ADDENDUM NO. 1

LOGANPORT FAIRVIEW ELEMENTARY SCHOOL RENOVATIONS **Logansport, IN 46947**

ADDENDUM ONE

Addendum One (AD.01) to the drawings and specifications prepared by Gibraltar Design and The Skillman Corporation for **Fairview Elementary School Renovations** for **Logansport Community School Corporation**, Logansport, Indiana.

E-105

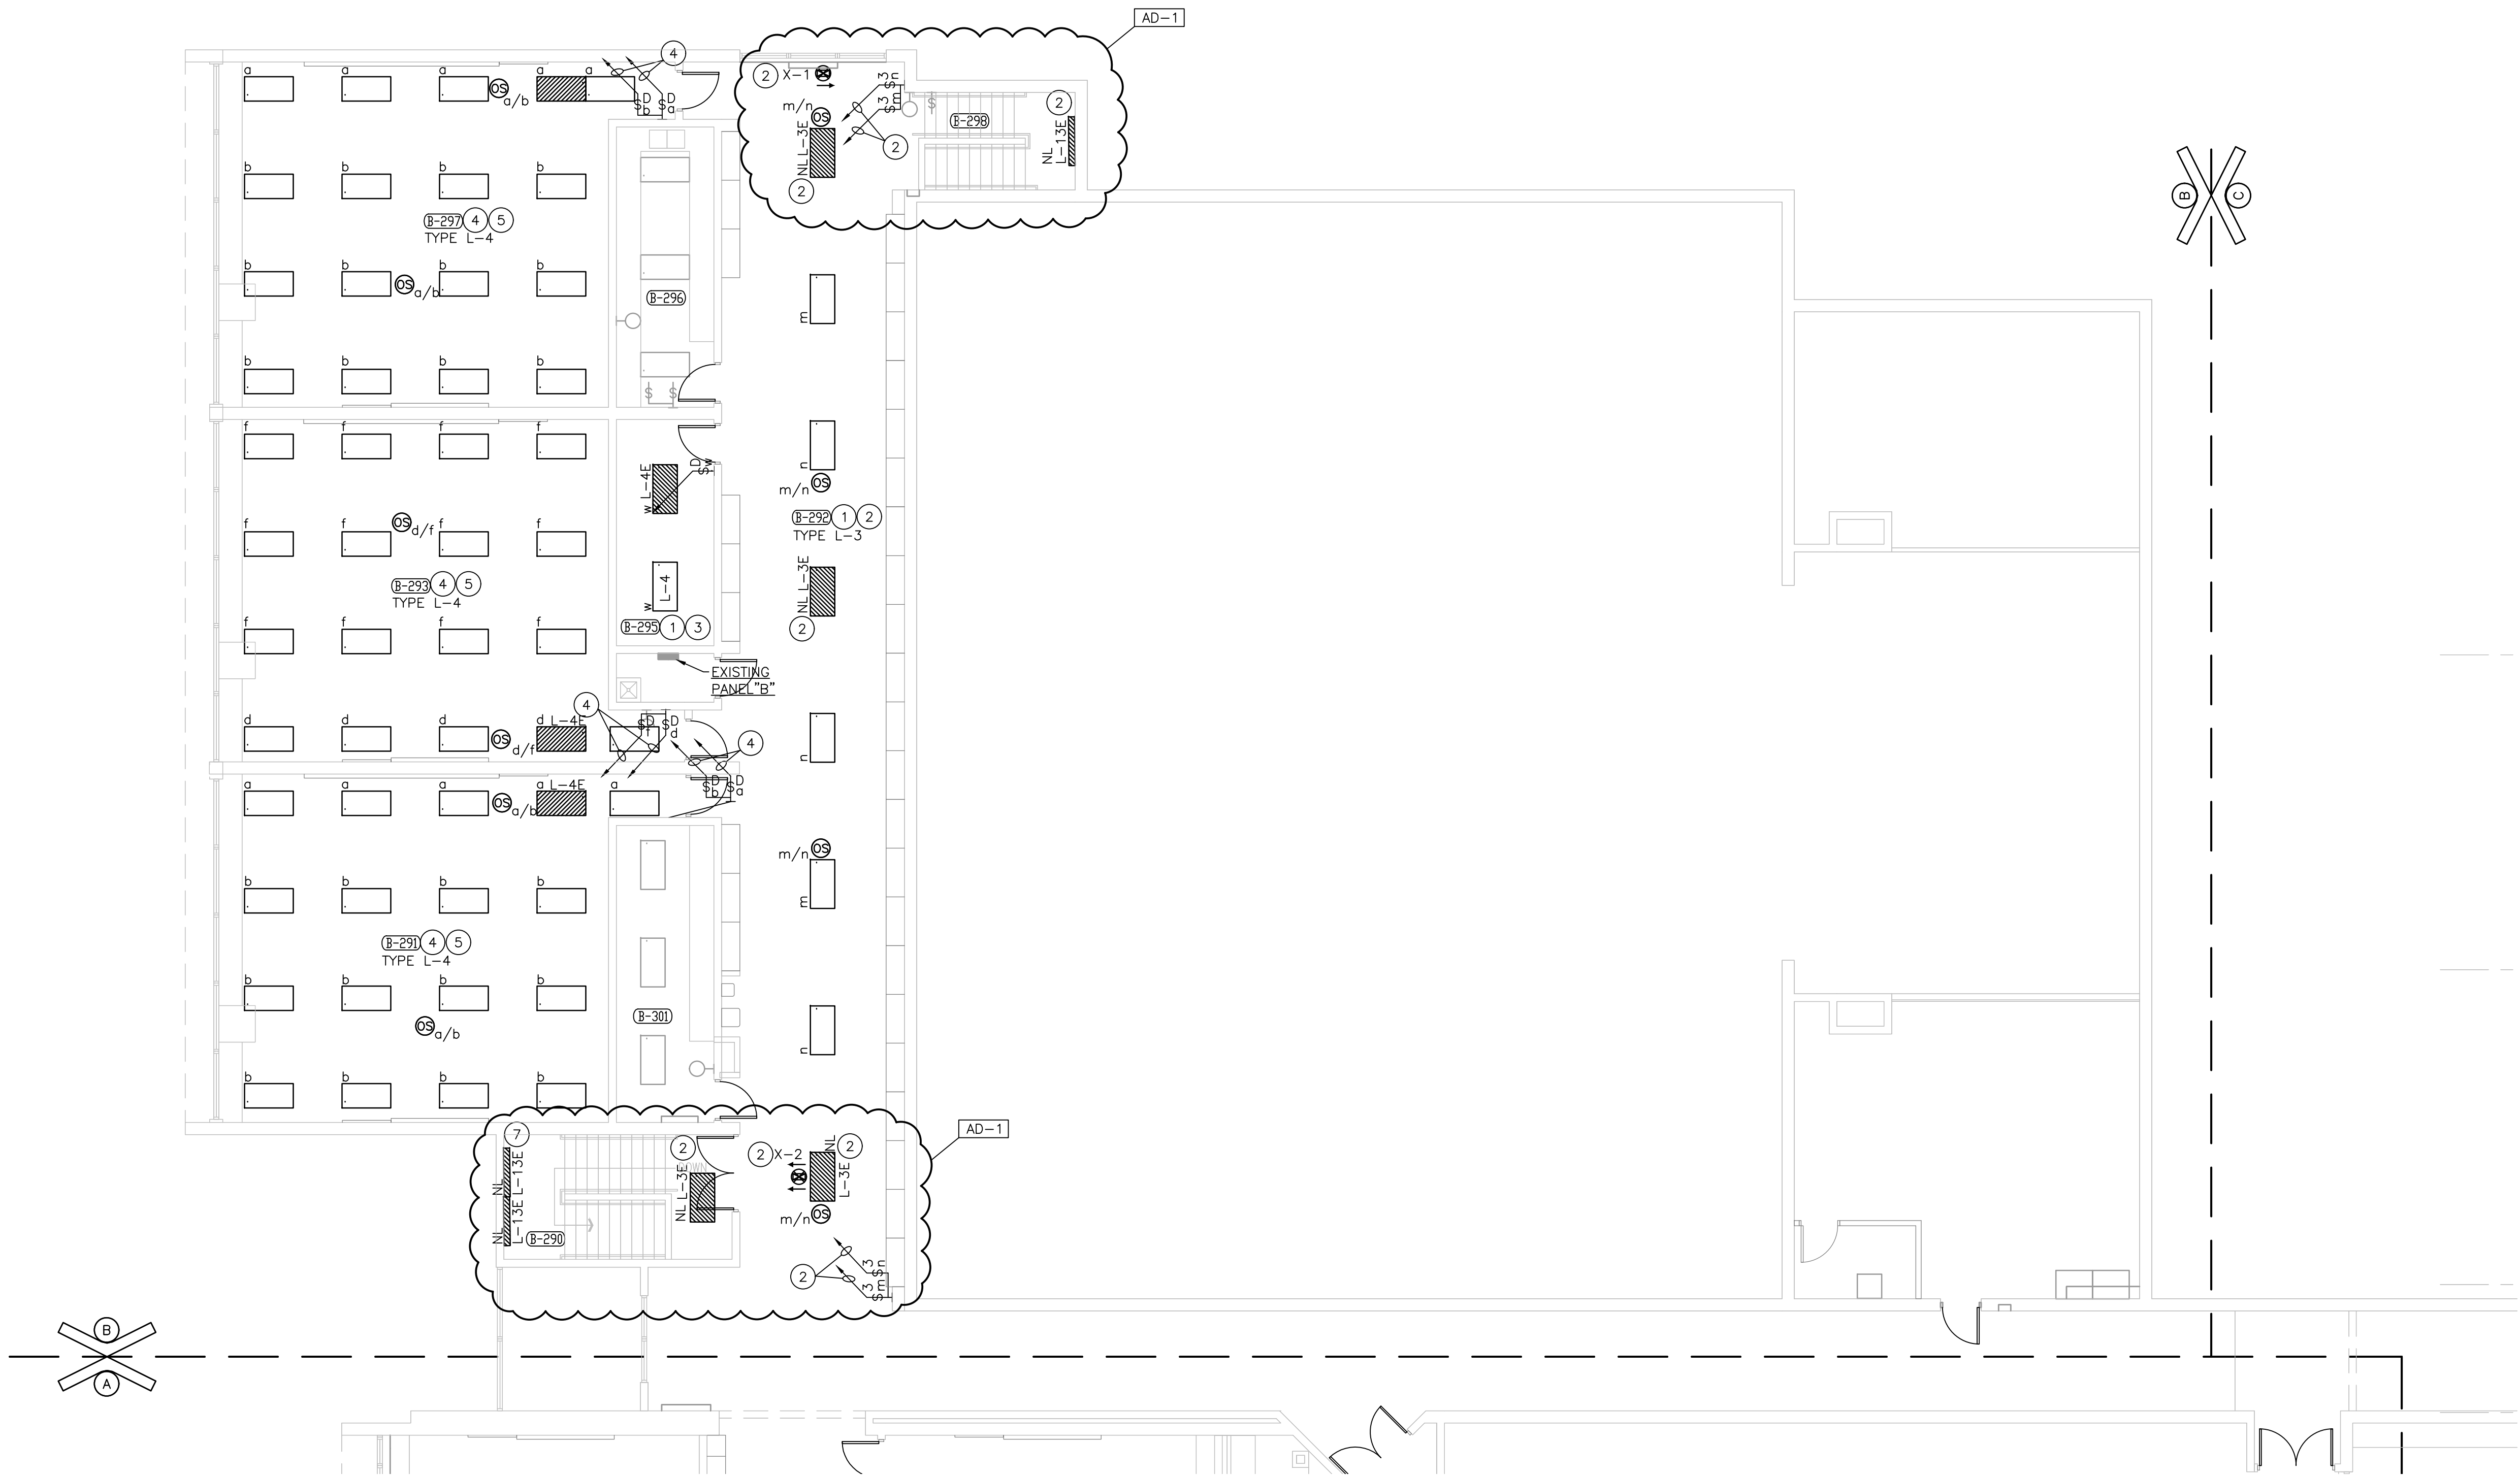
23. Sheet E-105

- A. Refer to revised full size drawing sheet, included in this addendum, for the following revisions.
 - 1. On Plan Notes 4, 5 and 6, delete the words "Under Alternate Bid". This work is to be under base bid.
 - 2. Stairs B-290 and B-298. Revising lighting in Stairs.

© GIBRALTAR DESIGN SHEET
E-202

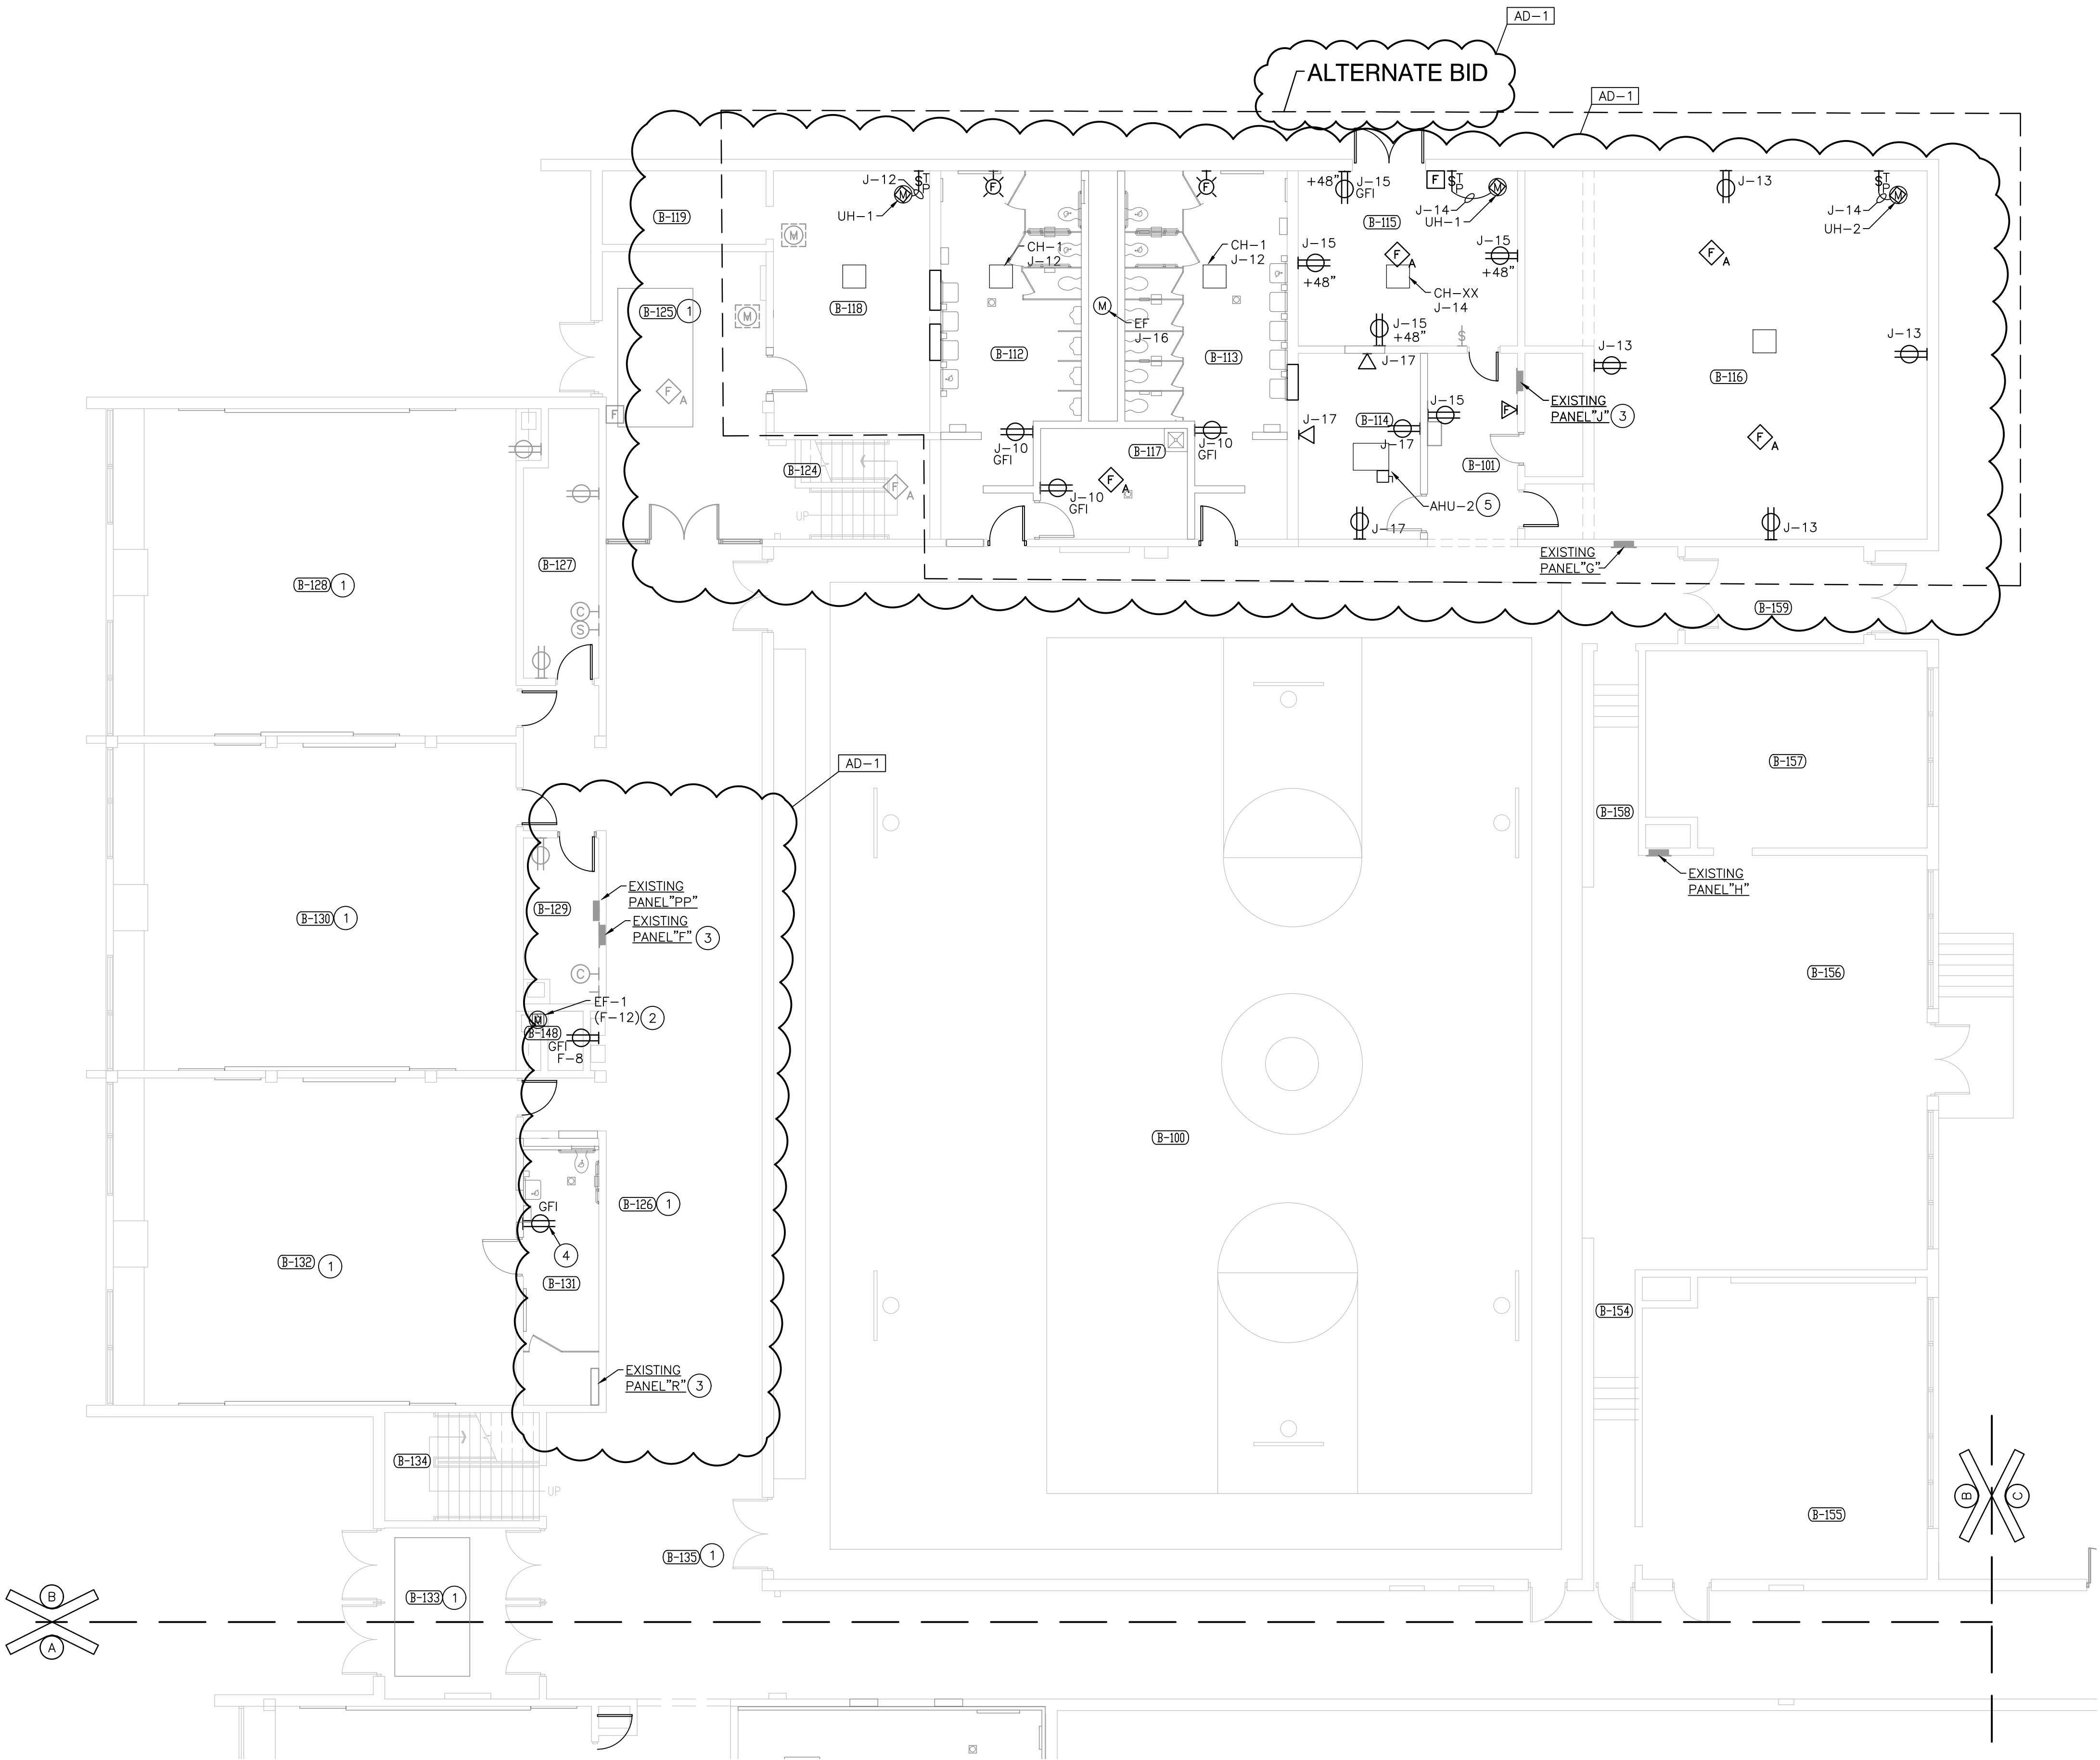
26. Sheet E-202

- A. Refer to revised full size drawing sheet, included in this addendum, for the following revisions.
 - 1. Modifying electrical connections to some of the mechanical equipment.
 - 2. Modifying electrical work in the renovated locker room areas.
 - 3. Note that the work enclosed within the dashed line is to be bid under an alternate bid.

EXISTING PARTIAL ELECTRICAL POWER DISTRIBUTION DIAGRAM

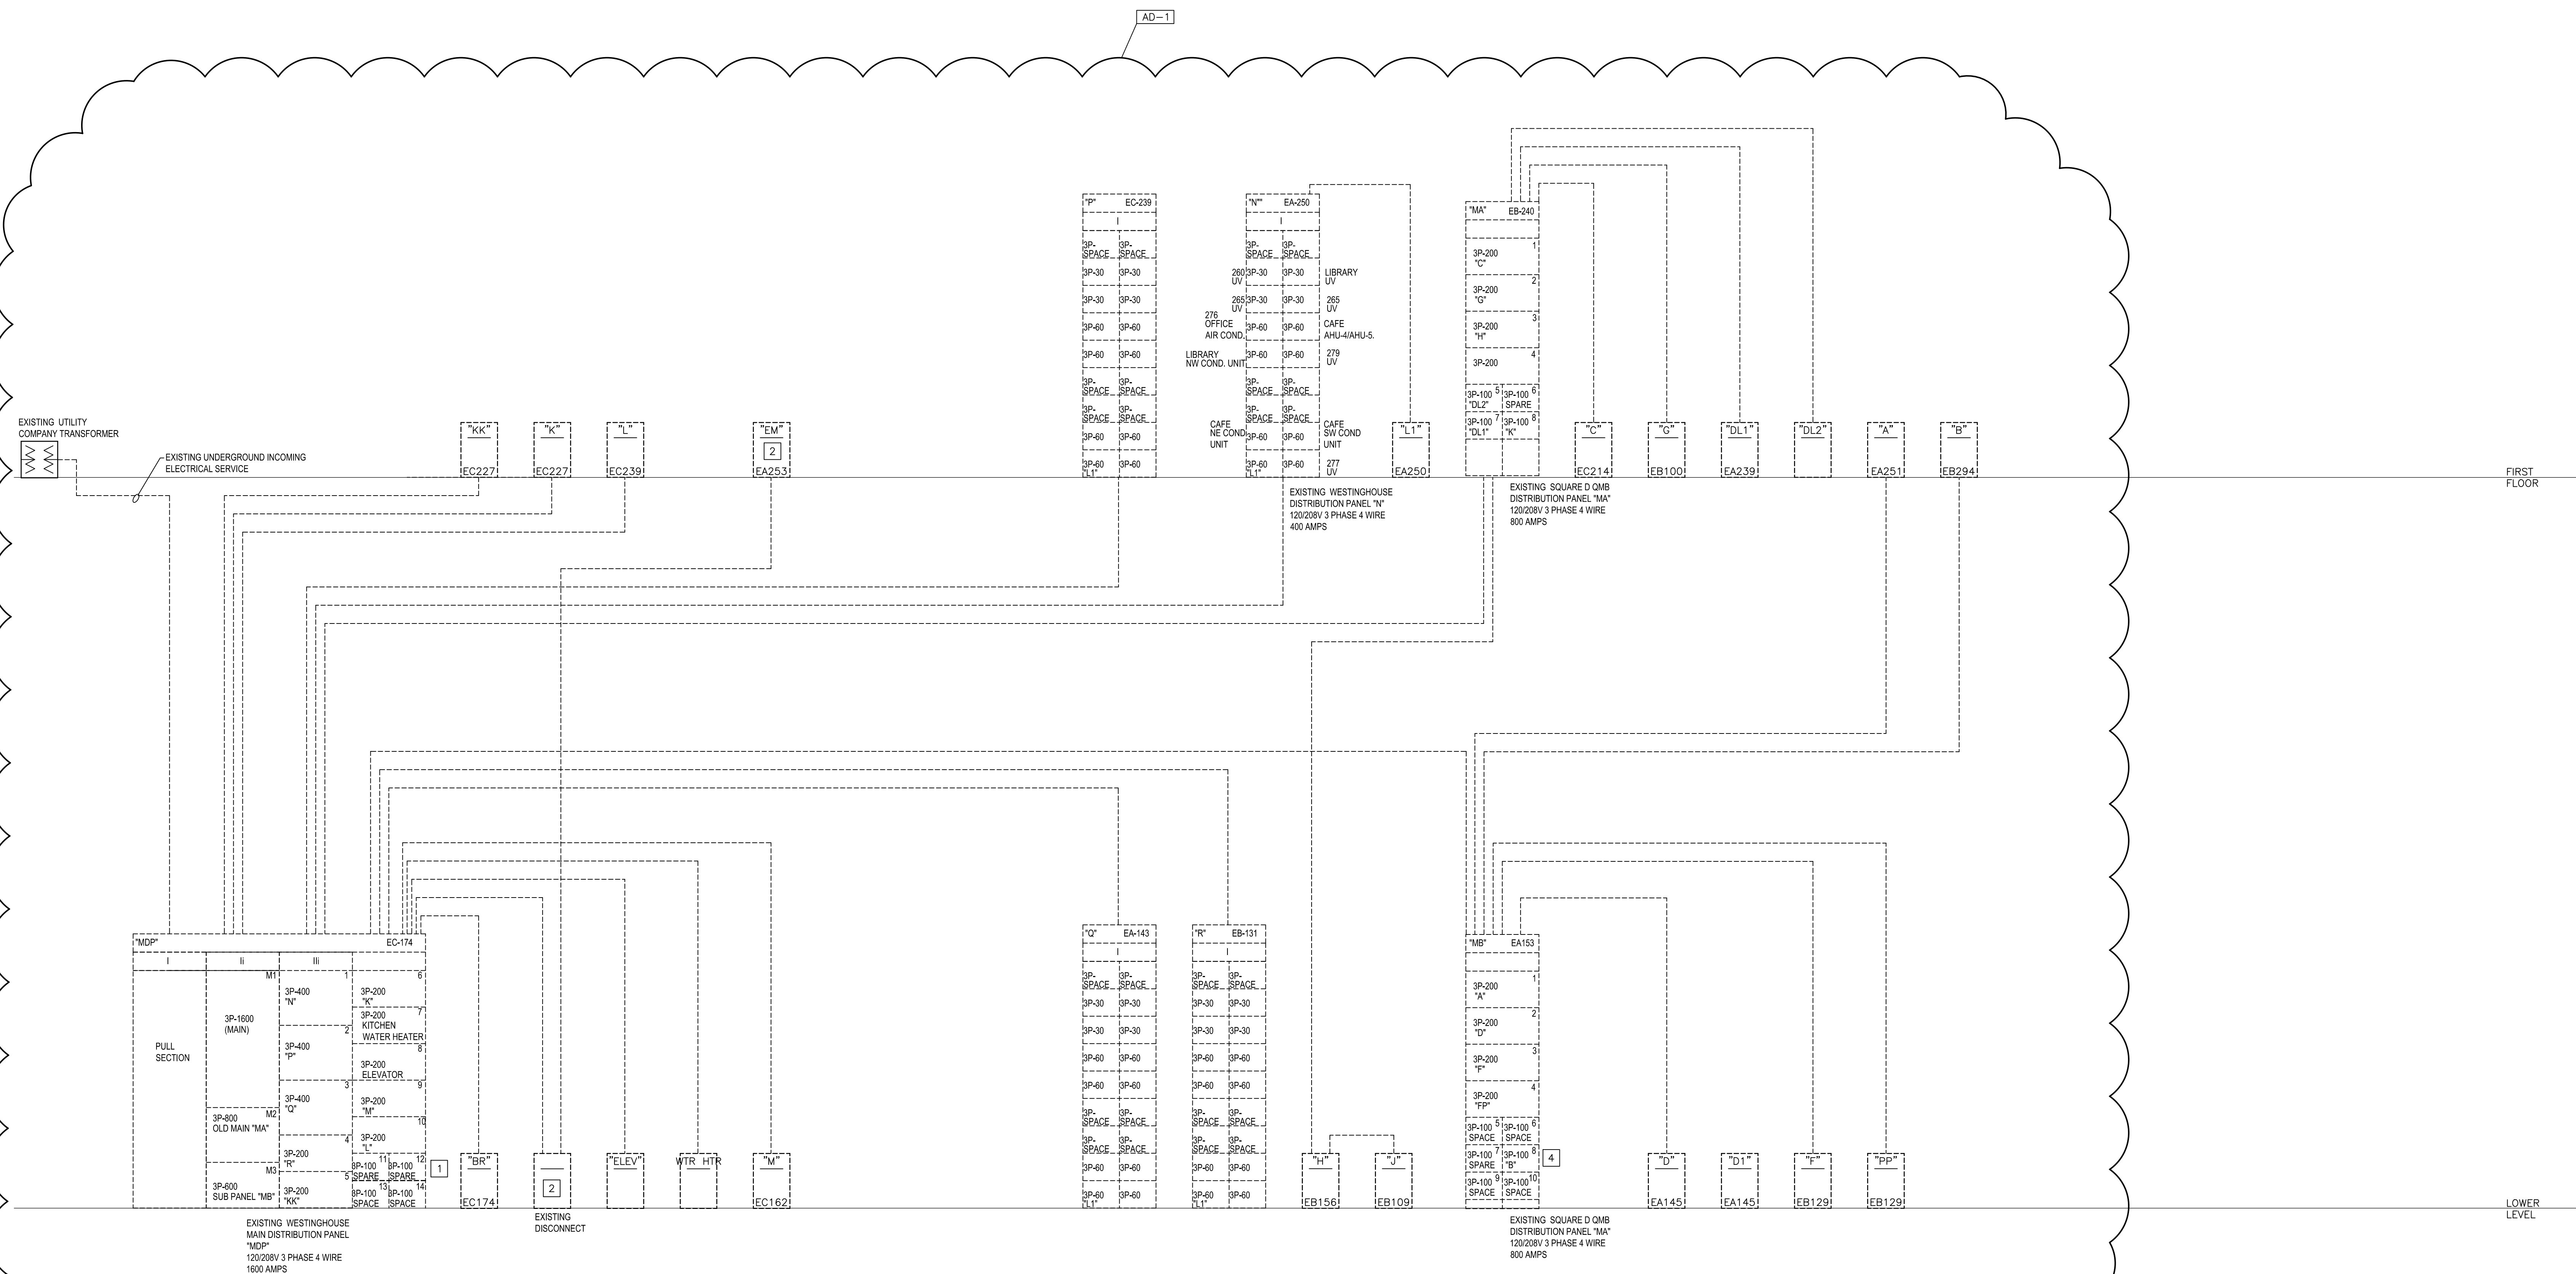
- A. Refer to revised full size drawing sheet, included in this addendum, for the following revisions.
 - 1. Revising Existing Power Distribution Diagrams.
